11 April, 2018

Addendum 1

Western Carteret Library Addition
Cape Carteret, North Carolina

SHEET NO.
BD-1
OF

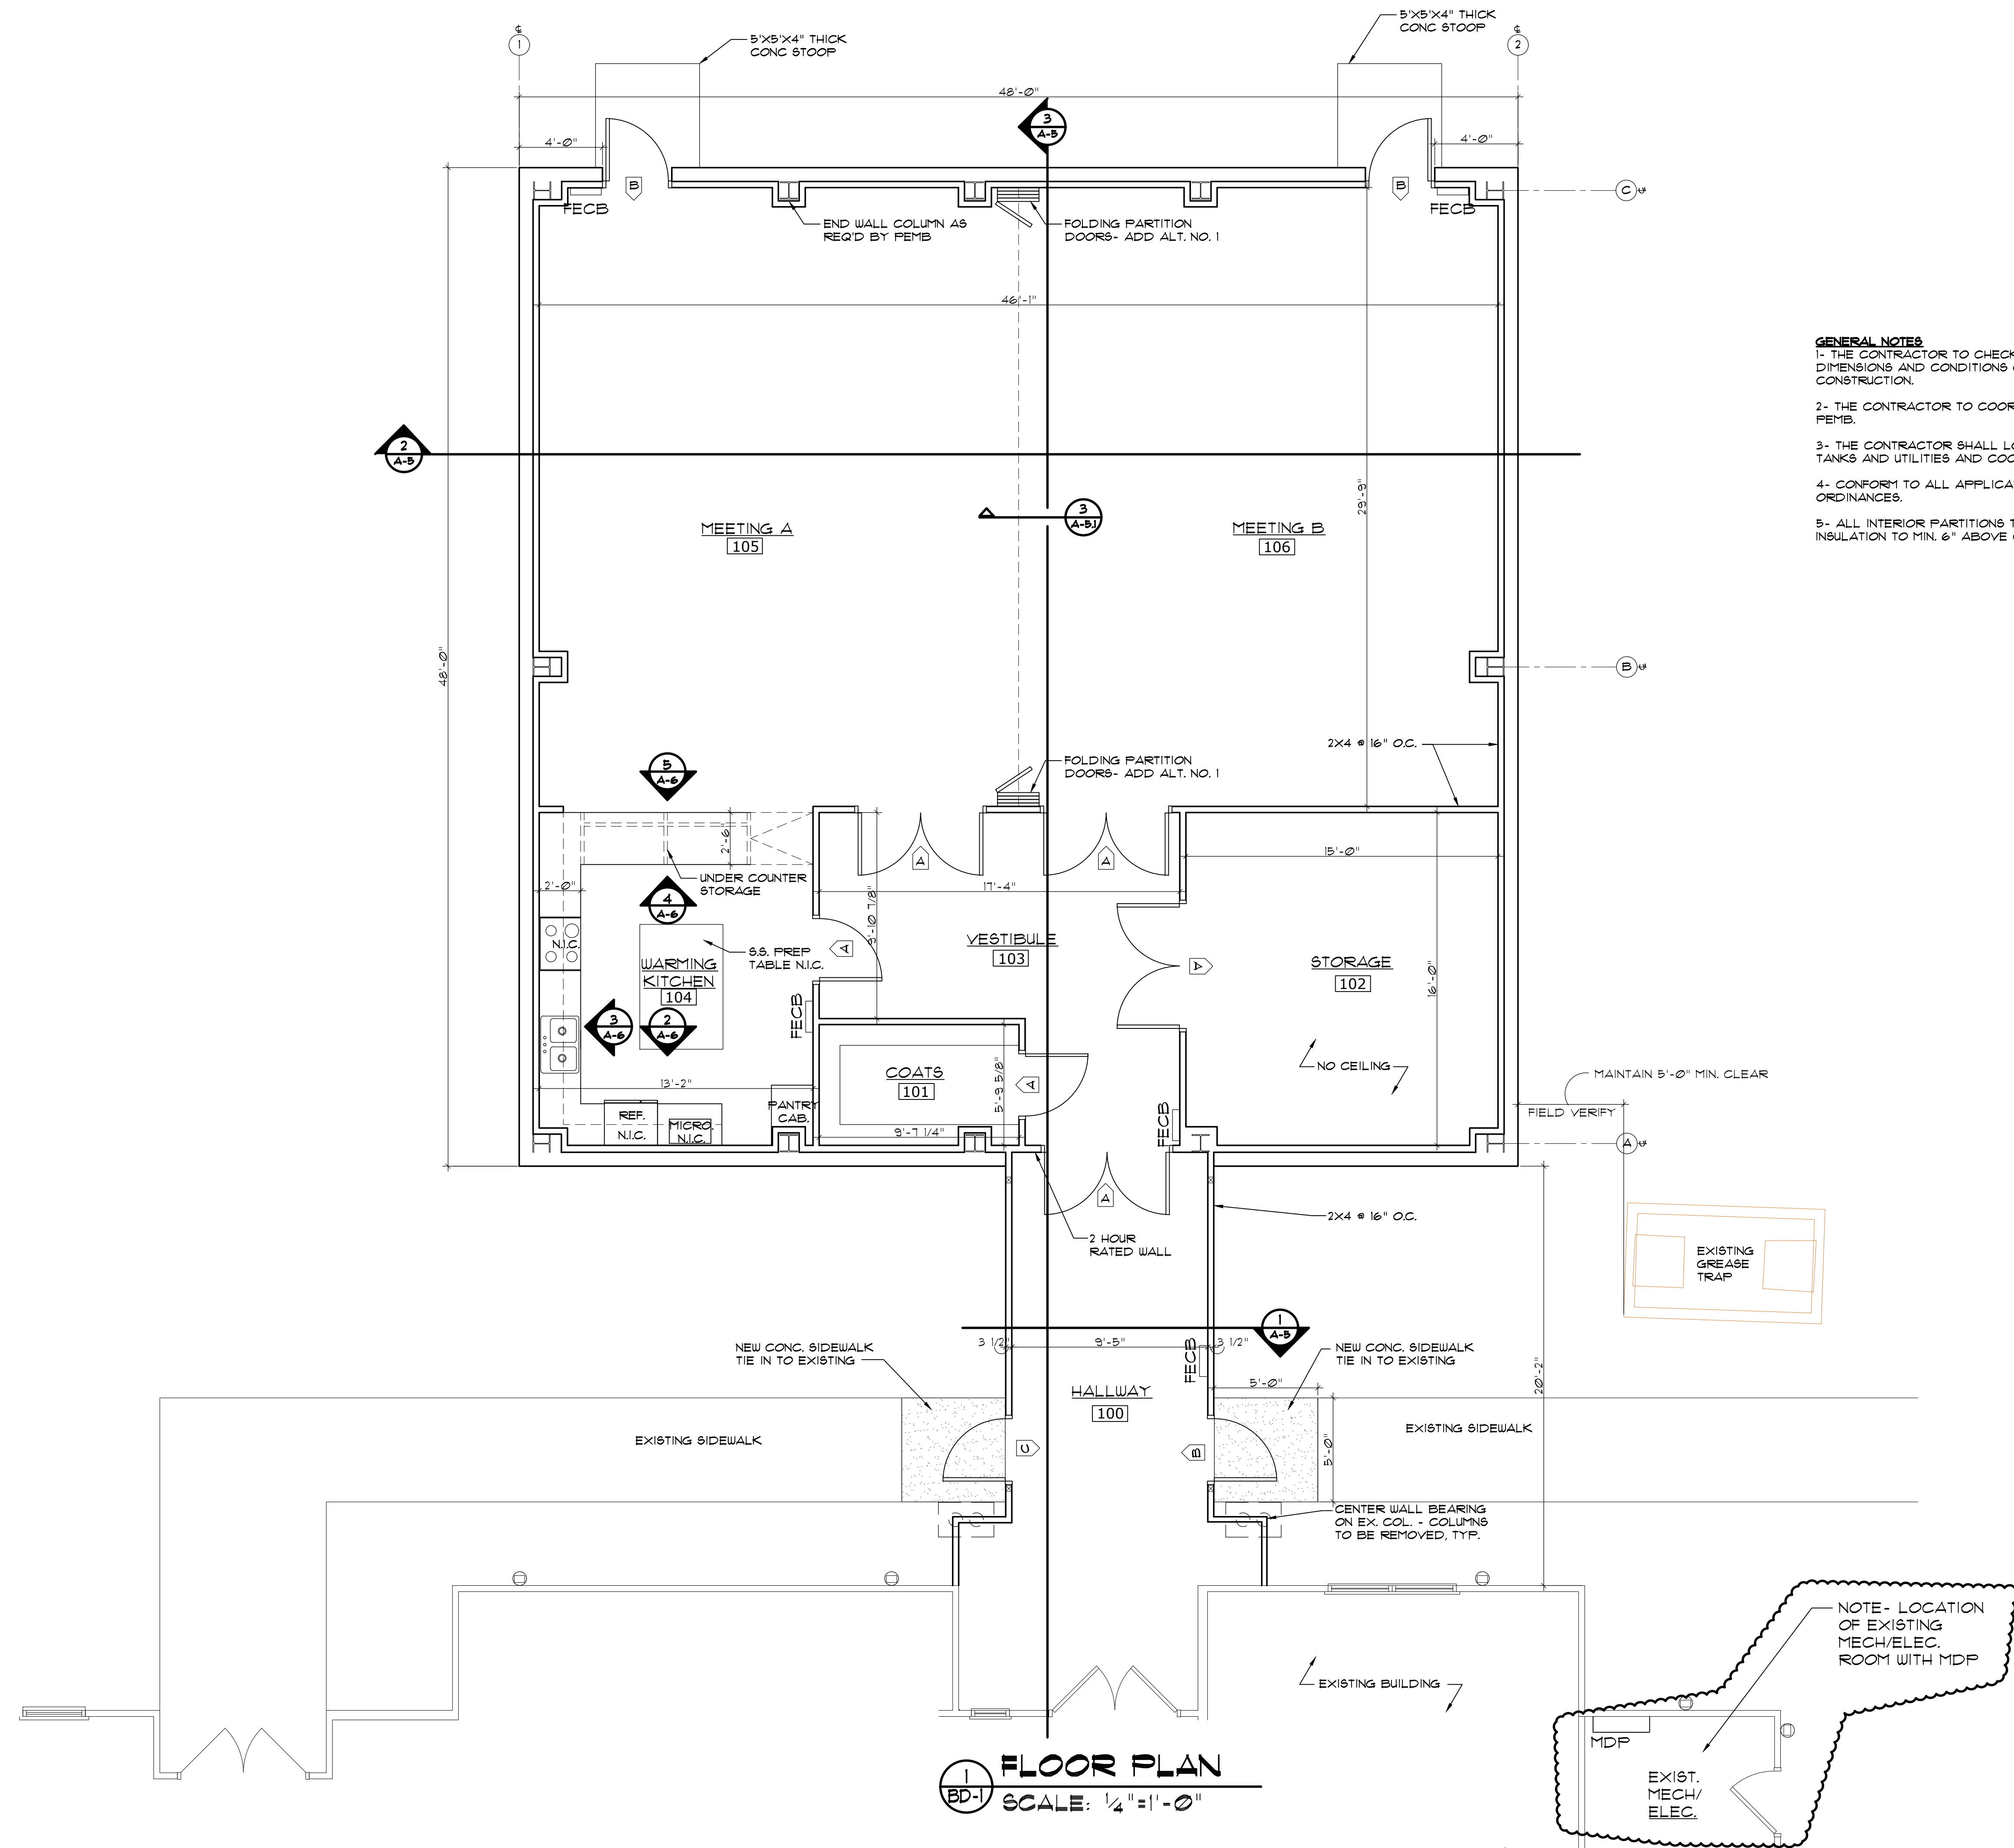
- Please note that the electrical MDP panel location is per the attached BD-1.
- Please note that the Contractor is responsible for applying for the building permit, but there will be no cost incurred for the price of the building permit. Any applicable charges by Cape Carteret Zoning shall be included in the bid.

NOTE - LOCATION OF EXISTING MECH/ELEC. ROOM WITH MDP
